REPORT

HOW01 - Technical Note - Variation to the DCO

Doc. no. 2251590
Ver. no.
Case no. 200-12-0444

Appendix 2: Location Plan and Indicative Layouts of the RCS and OSS

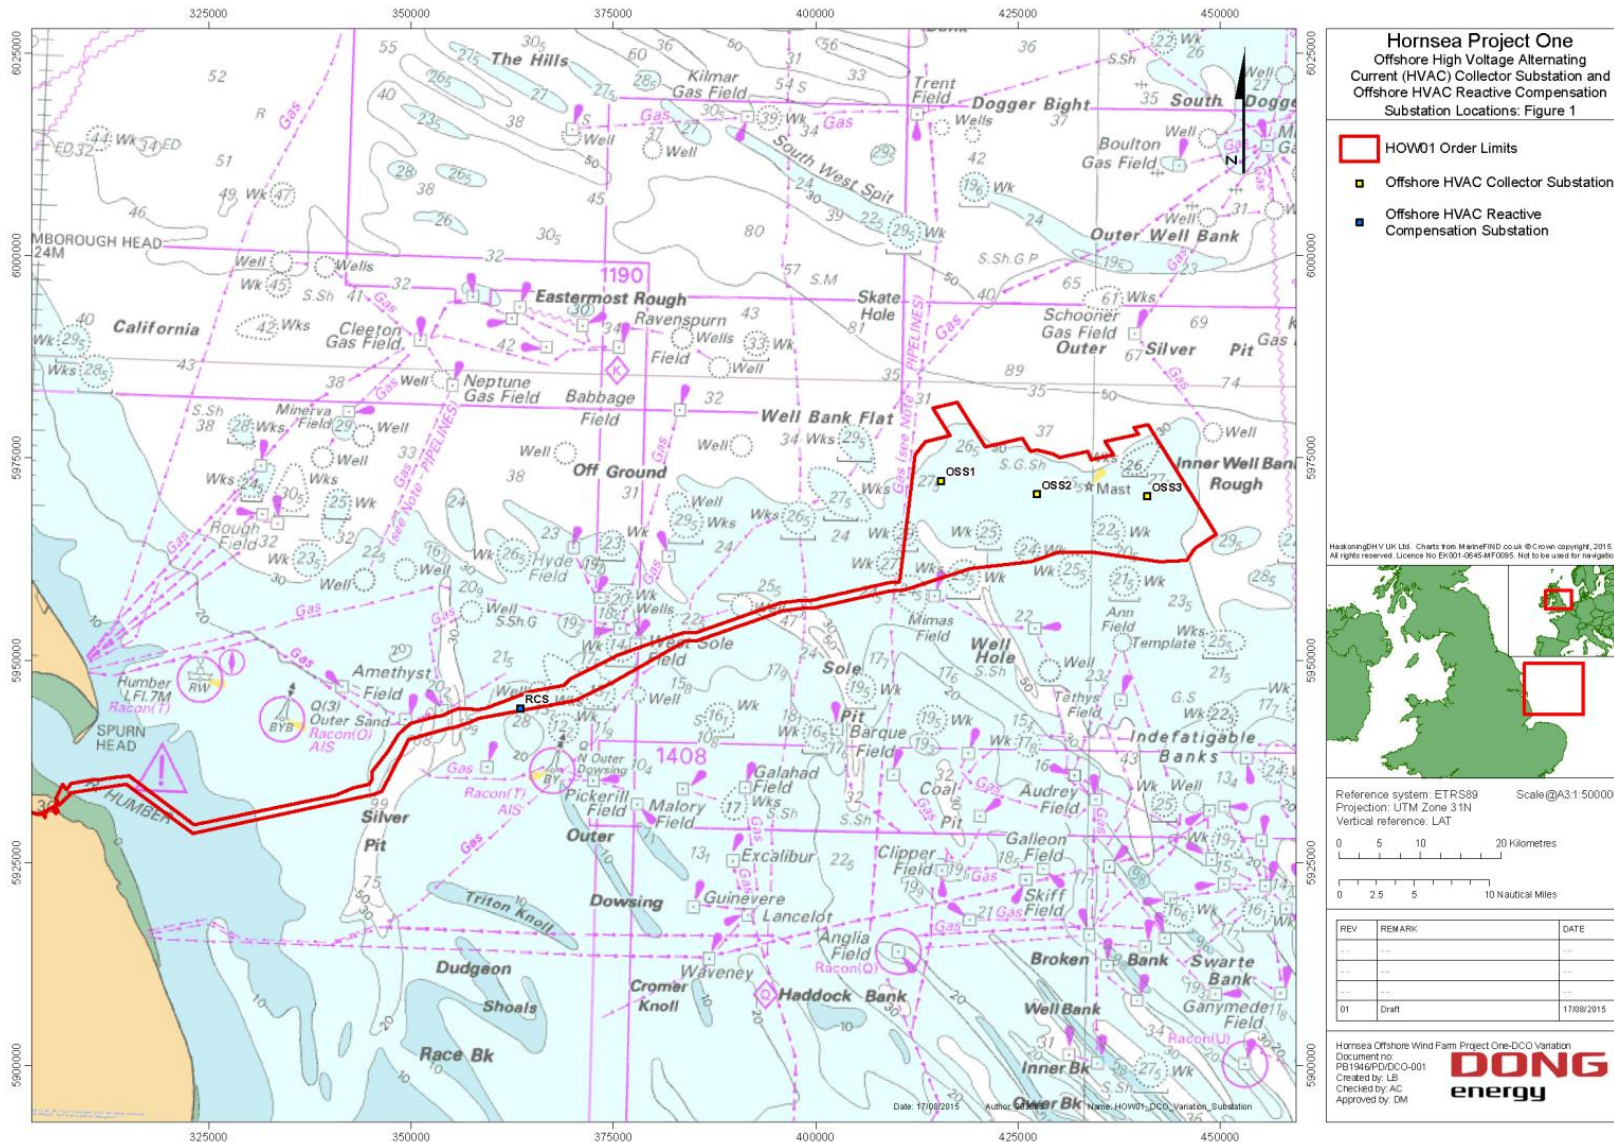
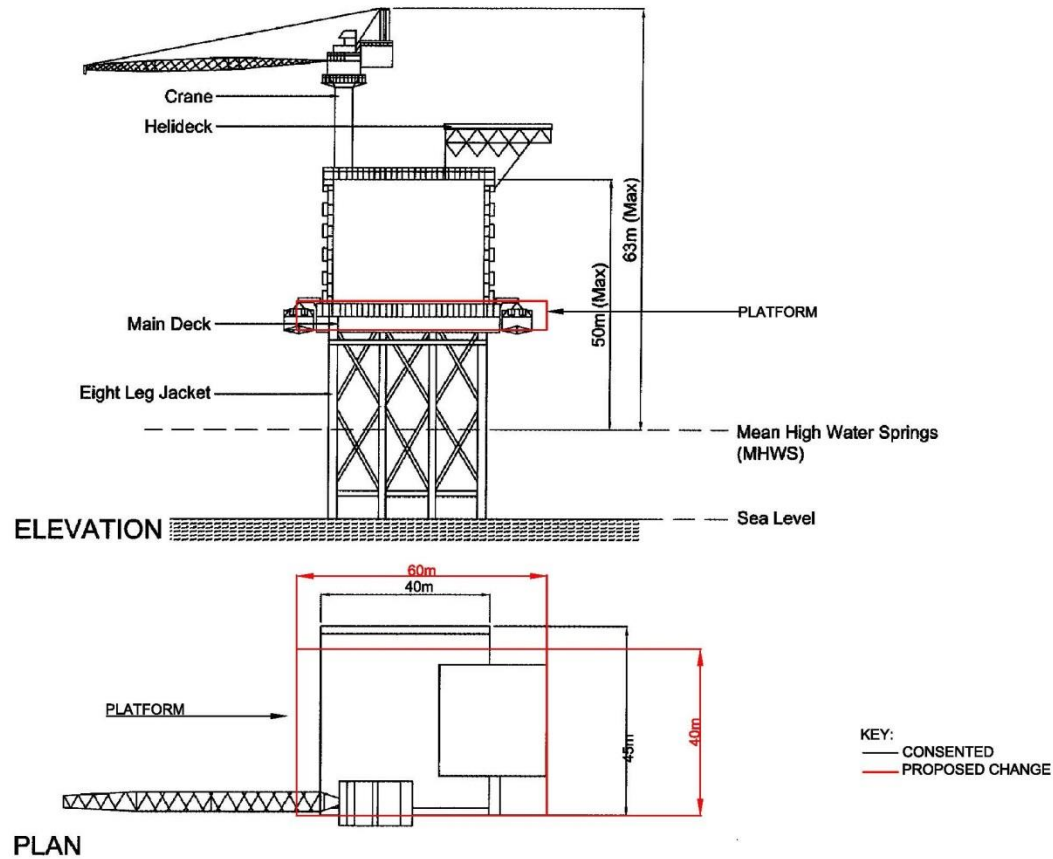
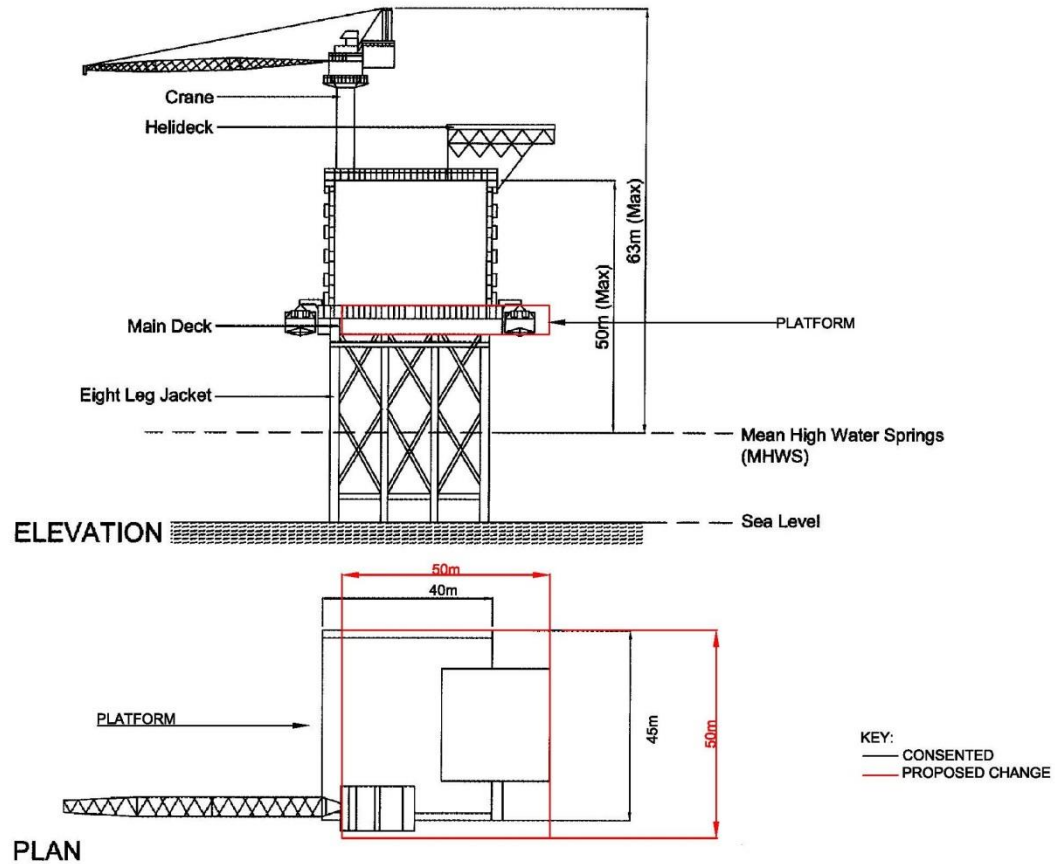
Subsequent to the DCO being granted it has been assessed that the OSS platform layouts may potentially need to exceed the consent envelope (i.e. the maximum dimensions of elements of the development imposed by the Requirements in the DCO within the overall red line area) due to helideck overhang. The helideck design must be suitable to accommodate large search and rescue (SAR) helicopters. The RCS platform layout may also be required to exceed the consented envelope due to helideck overhang and the need for a Radar Beacon (RaCon) to be installed. RaCons alert shipping traffic to the location of the substation to avoid collision. The installations of RaCons will require small cantilevers to extend out from the gangway. The DCO Requirements relevant to the OSS and RCS design are located in **Appendix 1** of this document, and the location plan and new indicative layouts of the RCS and OSS platforms are located in **Appendix 2** of this document. **Table 4.1** details the consented and the new required design envelopes for the OSS and RCS.

OSS: Current envelope			
Width	Length	Area	Height
40m	45m	1800m ²	60m (MHWS)
OSS: Required envelope			
Width	Length	Area	Height
40m	60m	2400 m ²	60m (MHWS)
RCS: Current envelope			
Width	Length	Area	Height
45m	40m	1800m ²	63m (MHWS)
RCS: Required envelope			
Width	Length	Area	Height
50m	50m	2500m ²	63m (MHWS)
